# Service Letter

## Drain Holes in Air Filter Box

**SL-ASTM-CTLS-02**

Fig.1

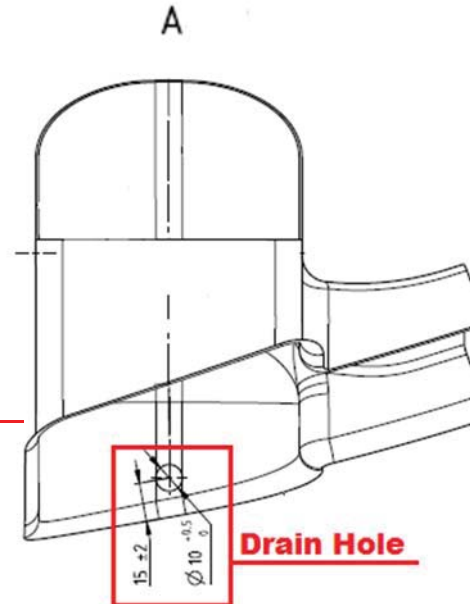
Type design includes a drain hole in the air filter box. As a result of a quality escape, in aircraft was delivered without such a drain hole. When flying through heavy rain, water can be trapped in the air filter box and the air filter can be moistened to a level that causes rough engine running in case of a missing drain hole.

In case when the drain hole is missing, is necessary to drill drain hole as shown below, see Fig.1, view A.

Detach the air filter together with cover from the filter box. Check the filter box to make sure the drain hole is observed.
